CERTIFICATE OF APPROPRIATENESS

Property: 1031 Le Green Street, Lot 13, Block 110, North Norhill Subdivision. The property includes a historic 1,190 square foot one-story wood frame single-family residence and detached garage situated on a 5,000 square foot interior lot.

Proposal: Alteration – Revision. Alter the fenestration of the existing south (front) and east elevations of the historic residence. The removal of the single original windows and installation of new wood paired windows on the front elevation, as well as the removal of a side window and installation of a smaller slider window, was denied at the July 2015 HAHC meeting. The applicant now proposes the following work:

Recommendation: Denial - does not satisfy criteria 1, 4, 7, 8, 9

SOUTH ELEVATION – FRONT FACING LE GREEN STREET

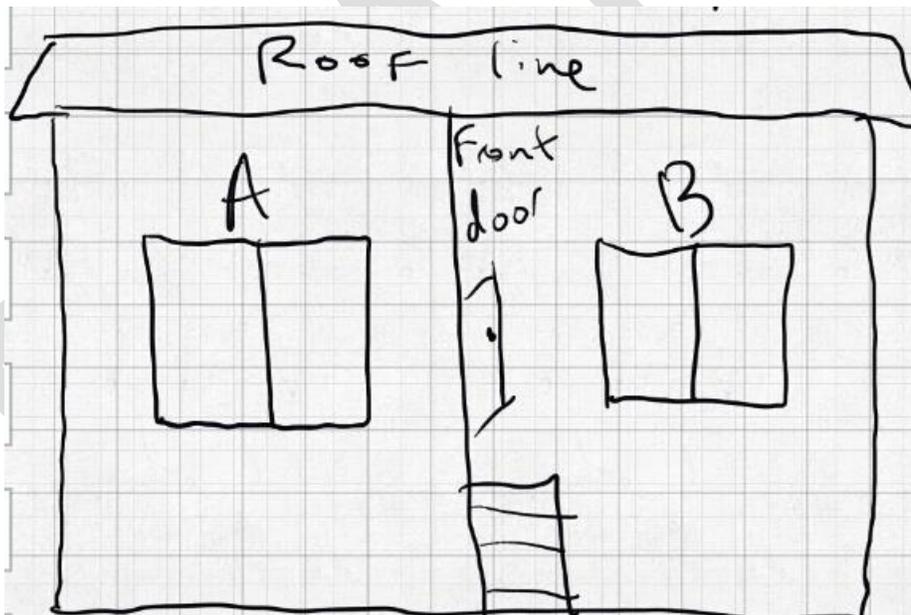
<i>The removal of the original windows, trim, and siding as well as the addition of paired windows to the façade of this building is highly visible and represents a failure to retain and preserve the historical character of the property.</i> |

<i>A single window located in each of the two front bays was a highly visible and distinguishing characteristic of this residence. No evidence has been submitted supporting that this residence originally had paired windows on the front elevation. Adding additional fenestration to the façade of this building is highly visible and alters its original historic appearance.</i> |

<i>No evidence has been submitted supporting that this residence originally had paired windows on the front elevation. Adding additional fenestration to the façade of this building is a highly visible and invasive alteration to its original historic appearance.</i> |

EAST SIDE ELEVATION

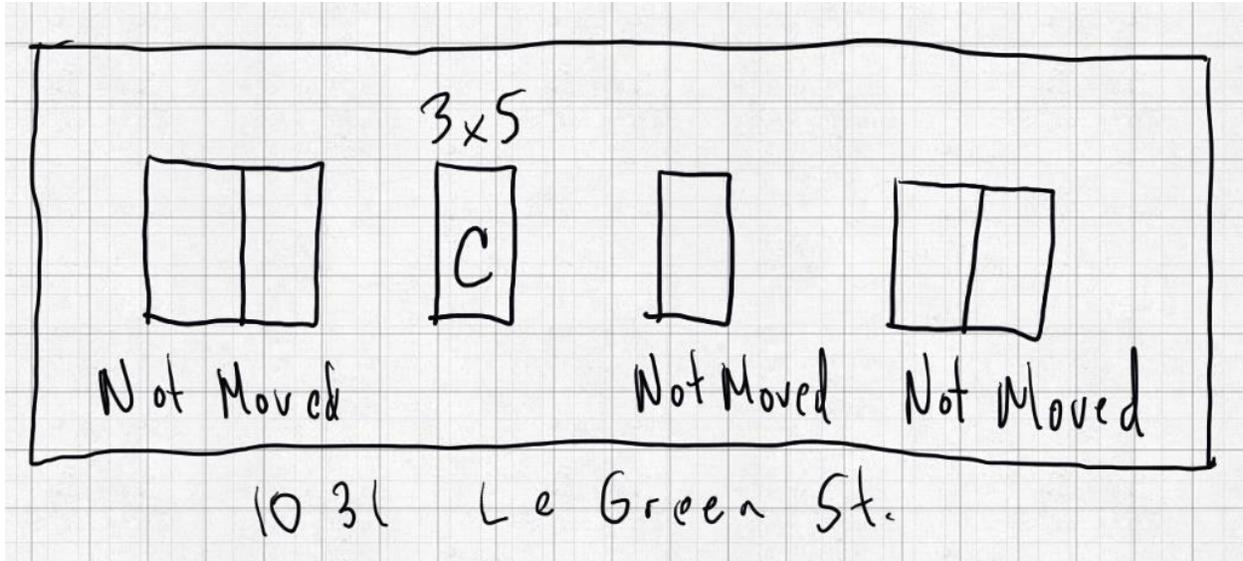
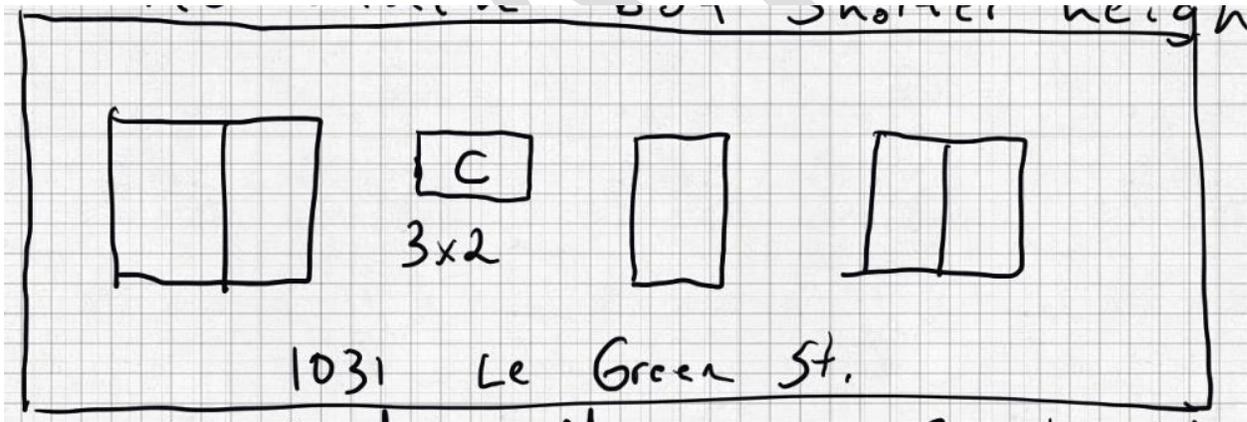
<i>The removal of existing historic windows, the expansion and alteration of the original window openings and the addition of paired windows on the façade and a smaller window on the east elevation impairs the integrity of the historic structure. Additionally, the shifting of windows is extremely invasive. As this is a balloon framed house, the walls will have to be reframed and headers installed to allow for proper installation of the new windows.</i> |
